Issue List

SPCC Aseptic Training Facility (Monroe, NC)

Project Issue Information

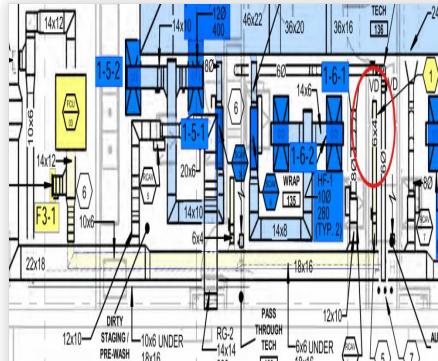
Issue Name : EF-2 Ductwork
Description : The Stainless Steel ductwork is installed, but the ports on the duct still need to be capped.
Created By : National TAB **Assigned To :** National TAB - Antonio Flores-De La Cruz
Status : Open
Priority : Urgent **Asset Tag :**
Originated Date : 03/17/2026 - Antonio Flores-De La Cruz - National TAB

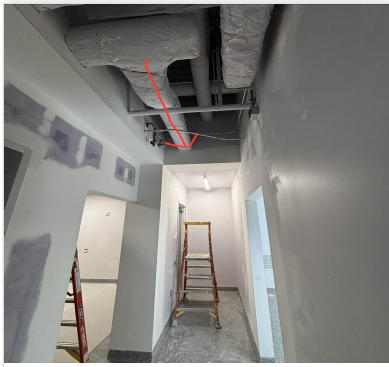
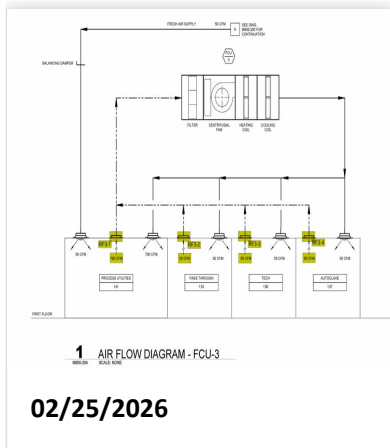
Issue Name : FCU F-3 missing damper
Description : Grille in AUTOCLAVE 137 for FCU F-3 is missing the OBD balancing damper. Also awaiting the Engineer's confirmation of increasing the grille from 50 CFM to 100 CFM, per the meeting on 2/19/2026.
Created By : National TAB **Assigned To :** National TAB - Antonio Flores-De La Cruz
Status : Open
Priority : Urgent **Asset Tag :**
Originated Date : 02/23/2026 - Antonio Flores-De La Cruz - National TAB

- **03/17/2026 National TAB - Antonio Flores-De La Cruz**
 - The supply duct in the AUTOCLAVE area goes into the wall but does not connect to a grille. It is inaccessible. The return damper for the FCU return grille in PROCESS UTILITIES 141 is not properly installed (One corner is floating) Also no answer on revised flows / ductwork. Damper for the supply not installed.

- All supply and return grilles need dampers. Also, an RFI is needed to determine the new diffuser values. The actual installation does not match the design and needs clarification.

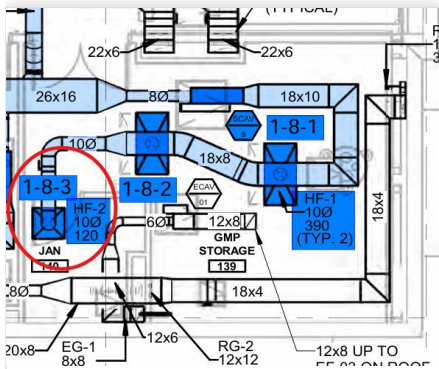
Issue Name : No Access Doors or Door Glass installed
Description : Access doors and door glass are not installed. Unable to pressure test and balance the return until installed.
Created By : National TAB **Assigned To :** National TAB - Antonio Flores-De La Cruz
Status : Open
Priority : Urgent **Asset Tag :**
Originated Date : 02/23/2026 - Antonio Flores-De La Cruz - National TAB

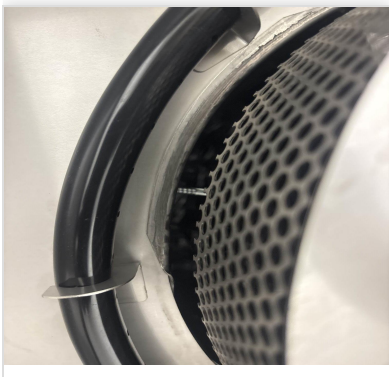
Issue Name : No Access to damper for SCAV-8 Grille
Description : Grille 1-8-3 has no access to the damper to balance. Also, unable to verify if the damper is installed. The VAV box is calibrated in the meantime.
Created By : National TAB
Assigned To : National TAB - Antonio Flores-De La Cruz
Status : Open
Priority : Urgent
Asset Tag :
Originated Date : 02/23/2026 - Antonio Flores-De La Cruz - National TAB

- **03/17/2026 National TAB - Antonio Flores-De La Cruz**
 - Attempted to use slider damper, unable to adjust to design because of screws.

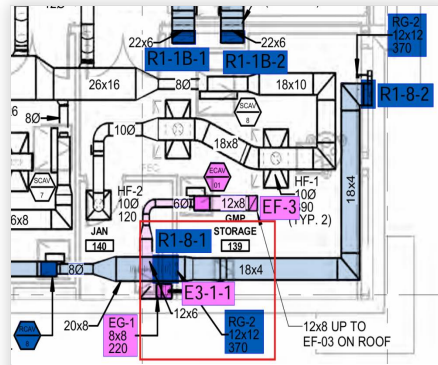
Issue Name : RCAV-8 Missing Grille / Low Airflow
Description : RCAV-8 is missing a grille. The VAV box is calibrated and can only achieve 640 CFM at 100% open damper. The rectangular duct attached to the grille appears to be sized for the 370 CFM design.
Created By : National TAB
Assigned To : National TAB - Antonio Flores-De La Cruz
Status : Open
Priority : Urgent
Asset Tag :
Originated Date : 02/25/2026 - Antonio Flores-De La Cruz - National TAB

Issue Name : VAV-1 Low Flow
Description : At 100% open damper at VAV, max flow is only (817 CFM ACTUAL / 1100 CFM DESIGN). K factor is 986. Pressure goes up to 0.65" wc. VAV box is 10". No obstruction is found to limit flow to the box. Ductwork should be inspected.

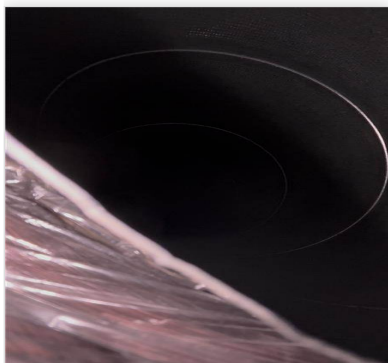
- **03/17/2026 National TAB - Antonio Flores-De La Cruz**
 - Will check again
- **02/25/2026 National TAB - Antonio Flores-De La Cruz**
 - To verify the interior structure of the duct, a small incision was made in the flex to view the portion hidden by the wall leading into the room. It is believed that the path the duct follows restricts airflow due to the transition from the duct to the flex and to the VAV. This is not a straight path and could add resistance. Also, it appears that a portion of the hard duct has been bent inwards, as shown in the attached picture, and is no longer circular.

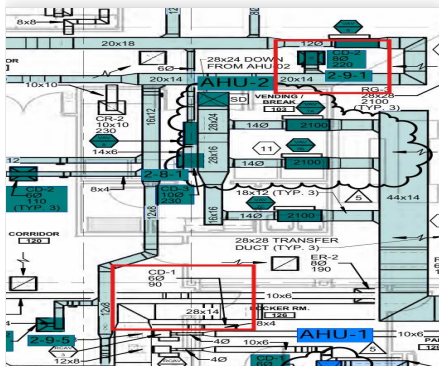
Issue Name : VAV-9 Missing Dampers
Description : Supply Diffuser in LOCKER RM 126 does not have a damper installed, as well as diffuser 2-9-1. 2-9-1 ductwork is also pinched and needs to be corrected.
Created By : National TAB **Assigned To :** National TAB - Antonio Flores-De La Cruz
Status : Open
Priority : Urgent **Asset Tag :**
Originated Date : 02/24/2026 - Antonio Flores-De La Cruz - National TAB

- **03/17/2026 National TAB - Antonio Flores-De La Cruz**
 - Diffuser 2-9-1 is still missing damper and pinched ductwork
